## PUBLIC HEARING MEMORANDUM

**SUBJECT:** **Petition #480-24** for SPECIAL PERMIT/SITE PLAN APPROVAL to rezone 1 parcel as follows: 386-394 Watertown Street from BUSINESS USE 1 to MIXED USE 4.

**Petition #481-24** for SPECIAL PERMIT/SITE PLAN APPROVAL to construct a four-story mixed use building with 13 residential units and 14 at grade parking stalls with relief relative to parking and the overall site and building plans at 386-394 Watertown Street

**386-394 Watertown Street**

### Previously Approved First Floor Floorplan

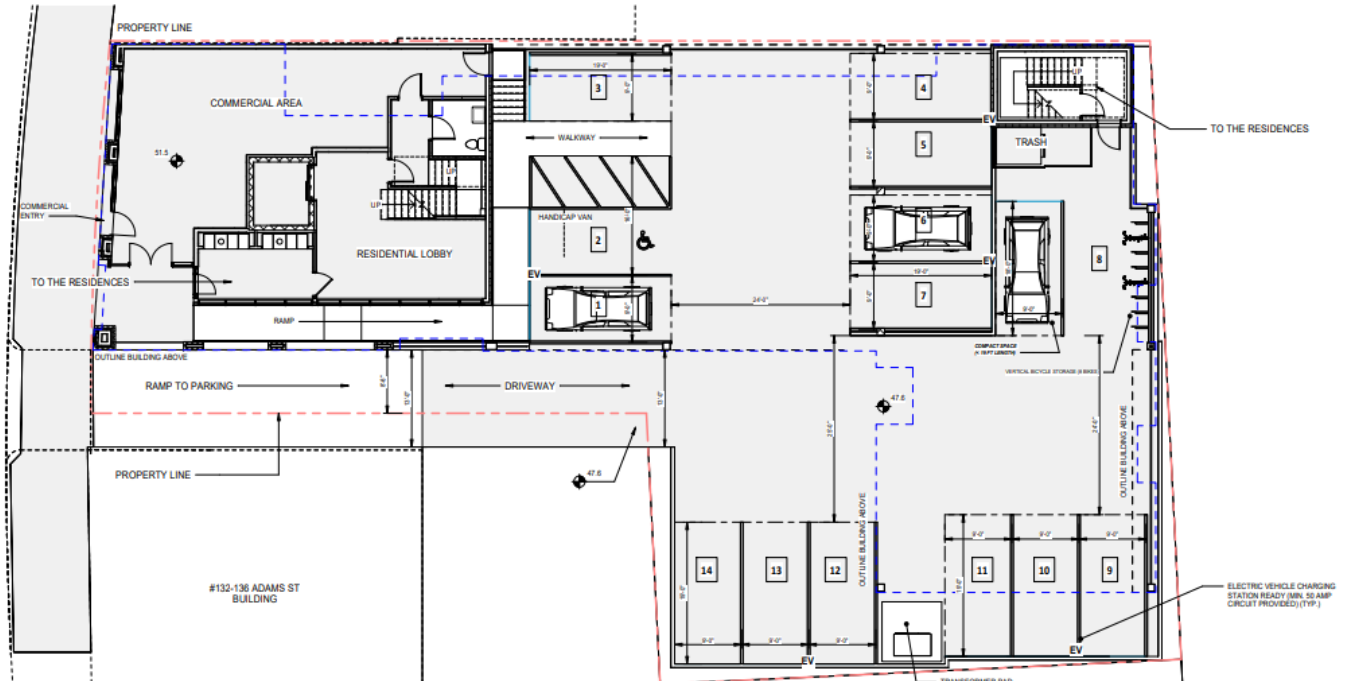
With the proposed changes, the project proposes to reduce the overall parking count from sixteen parking stalls to fourteen parking stalls and retains a similarly sized bicycle storage area. Maneuvering aisle width will be 24 feet, removing the need for the relief granted under Special Permit #302-21 where the ramp from the lower to upper level spanned twenty feet. There will be six restricted end stalls whereas the previously approved plans appeared to contain ten restricted end stalls.

The previously approved plans showed a two-foot-tall retaining wall along the right and rear

property lines. An additional retaining wall is proposed along the left property lines. While top of wall (TOW) measurements were provided, there are no bottom of wall measurements to confirm the heights of these walls. They appear not to exceed two feet in height when taking into account the topographical lines on the survey, but the petitioner needs to confirm the wall heights using top and bottom of wall measurements.
